## CITY COUNCIL SPECIAL MEETING/WORKSHOP AGENDA

**1.** Cedar Street Reconstruction Project - *action item*

**TODAY'S DATE:** March 3, 2025  
**MEETING DATE:** March 12, 2025  
**TO:** MAYOR AND CITY COUNCIL  
**FROM:** Holly Ellis, Public Works Director  
**SUBJECT:** Information in Preparation for Special Meeting for the Cedar Street Reconstruction Preliminary Design

ROADWAY OVERALL PLAN

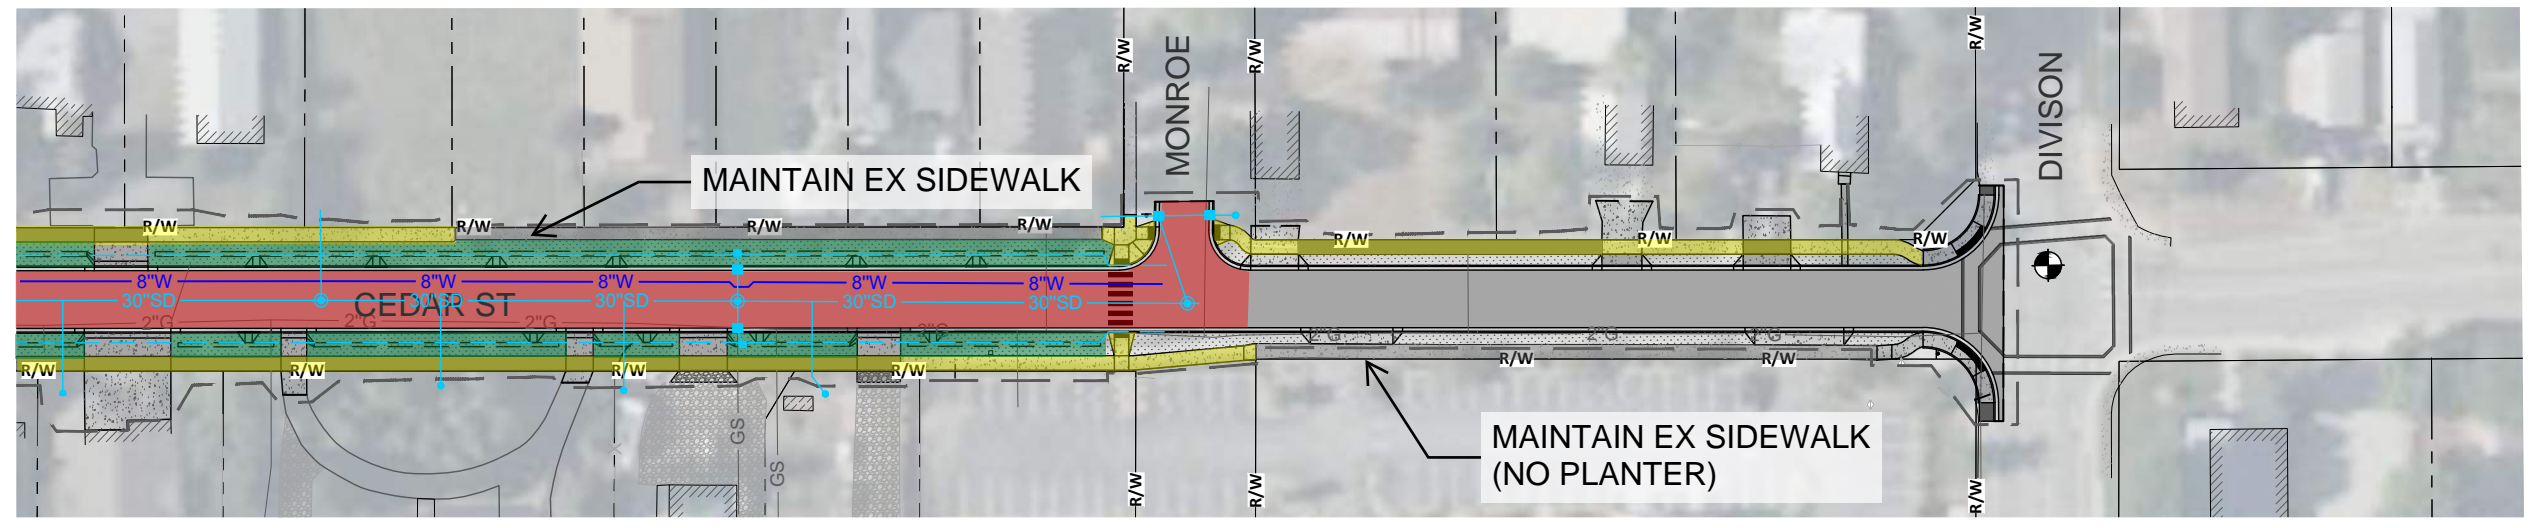
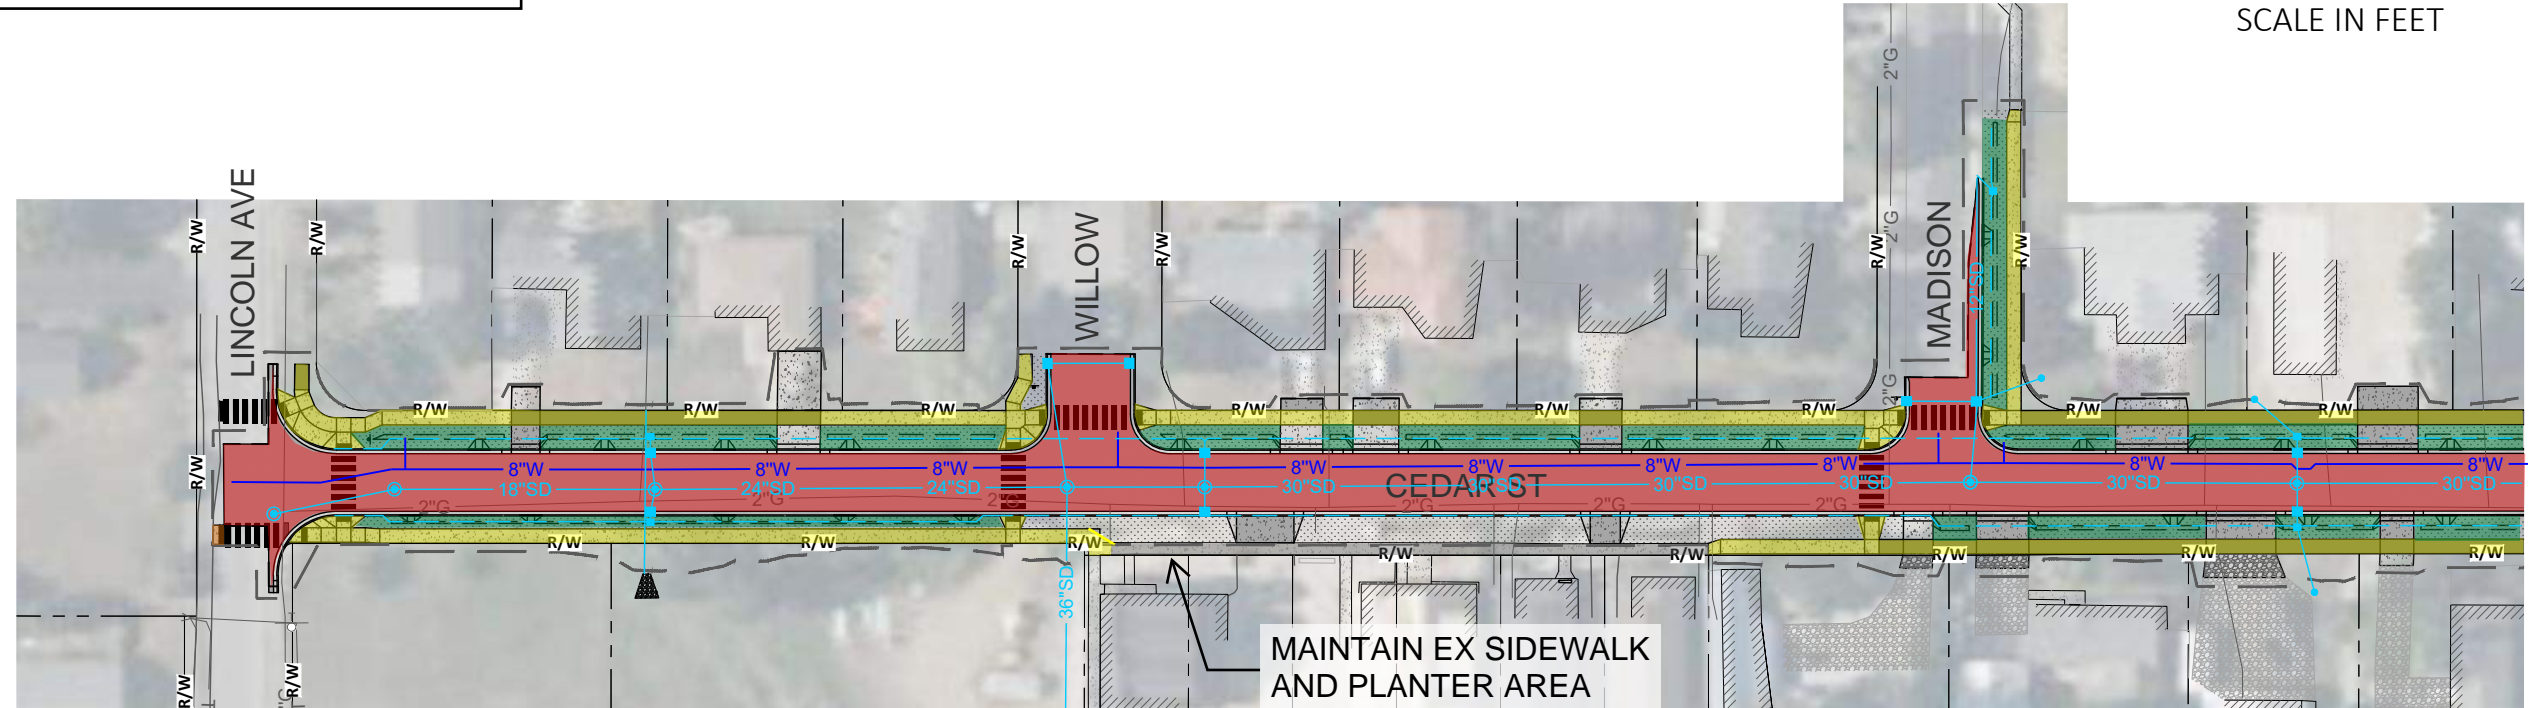
I recommend a 32' paved section (not 24') to provide two 12' travel lanes and one 8' on street parking lane; sidewalk and planting strip along south side only (a sidewalk/planting strip on north side is redundant).

I recommend that a 32' wide paved section be provided in order to accommodate on-street parking. A 24' wide paved section has been designed which will not accommodate on-street parking. One, 8-foot wide parking lane will at least provide some on-street parking. Note that when a vehicle is currently parked on-street, two vehicles cannot pass. (Cedar Street currently averages about 24 feet in width.) Emergency vehicle access is restricted. I further recommend that this additional paved section width be designed in lieu of the redundant north side sidewalk and planting strip. A south side sidewalk and planting strip is already proposed. A north side sidewalk and planting strip across the street from the proposed south side sidewalk and planting strip is not necessary, is impractical and is not as critical as is a wider paved section to accommodate some on-street parking.

Based on your practical suggestions and my need to temporarily occupy the right of way as noted, it would make sense to position the north curblin an additional 8' north of the alignment shown on the draft plans set and expand the pavement section from 24' to 32' to the north along the south boundary of my lot. You mentioned widening this paved section not just in front of my lot, but perhaps for the entire block between Willow Drive and Lincoln Ave. This makes *more* sense than only widening the paved section in front of my lot. Stormwater can simply be hard piped along this widened paved section as it is presently, and as it is shown on the plans set.

1. A 32' wide paved section adjacent to and in front of my lot (or the entire block as you see fit); and
2. An 18' wide driveway from the north right of way boundary to the face of my garage and the construction limits revised accordingly.

DEMOLITION OVERALL PLAN

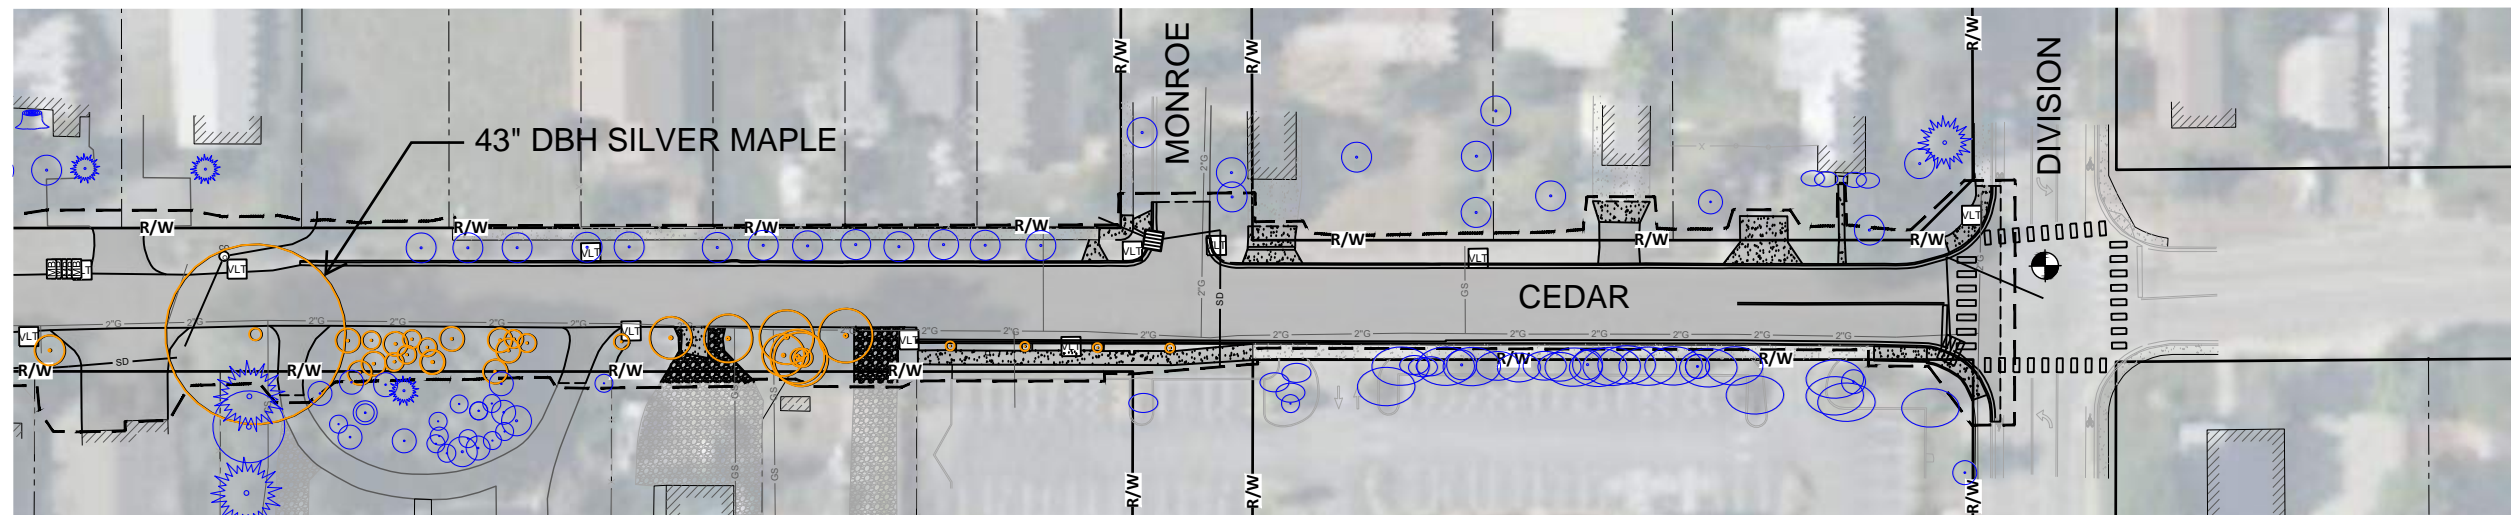
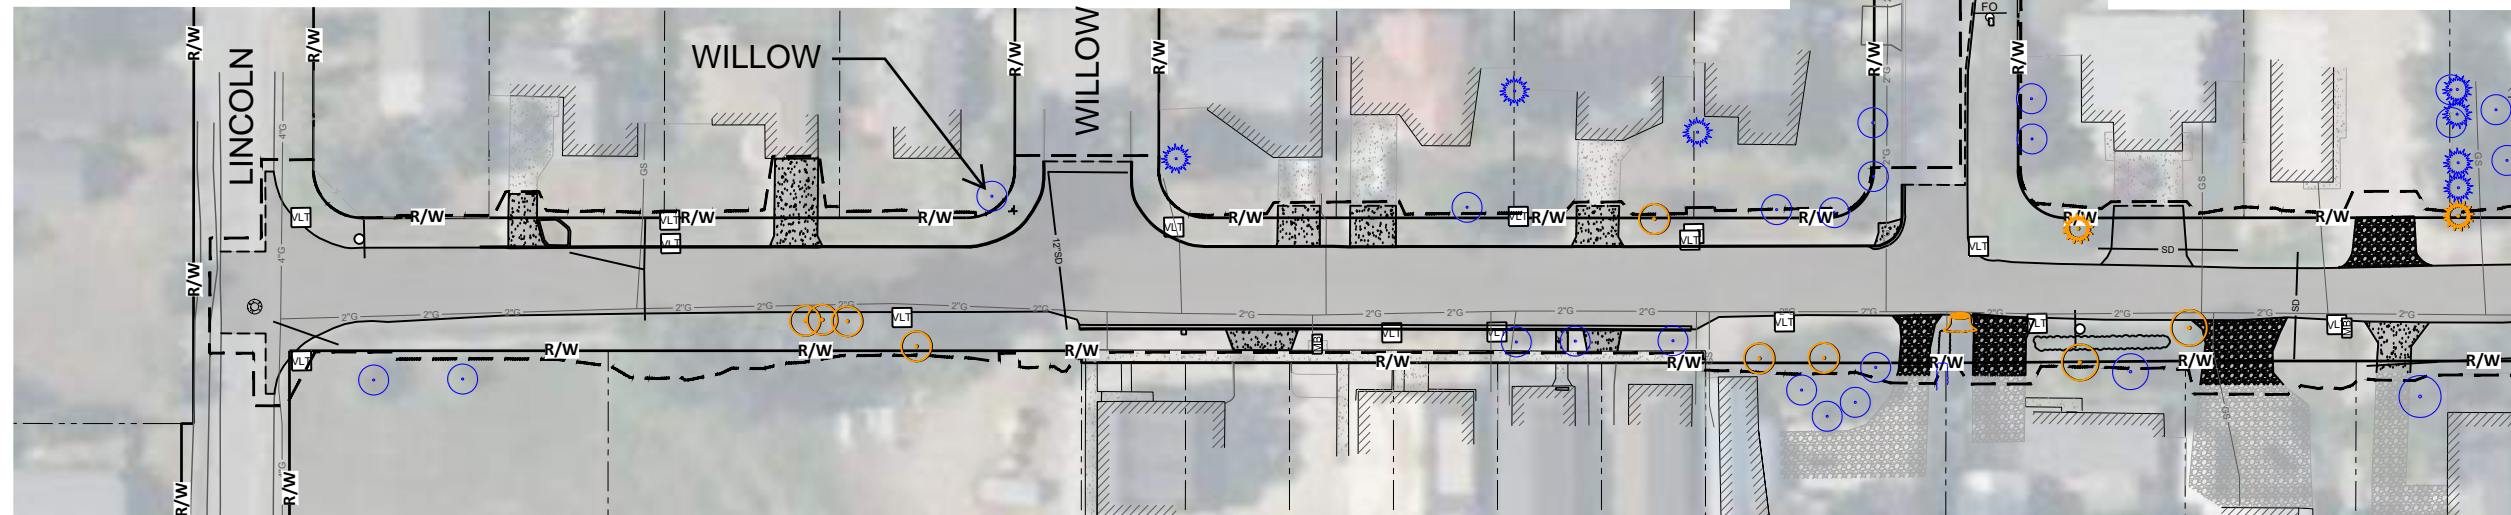
Forestry Commission expressed the importance of preserving the large silver maple located on the south side of Cedar Street between Madison and Monroe.

Cedar green ROW & other trees to remain. Rec protection plan be included in contract docs. Boul. Ground cover, consider xeriscape for lawn maintenance long term.

If tree preservation remains a priority, a protection plan must be implemented to maximize the chances of maintaining the tree while allowing necessary road reconstruction. Regular monitoring and adaptive management will be essential for long-term tree health. Tree protection measures would be prescribed by the engineer and a certified arborist and may include the following measures:
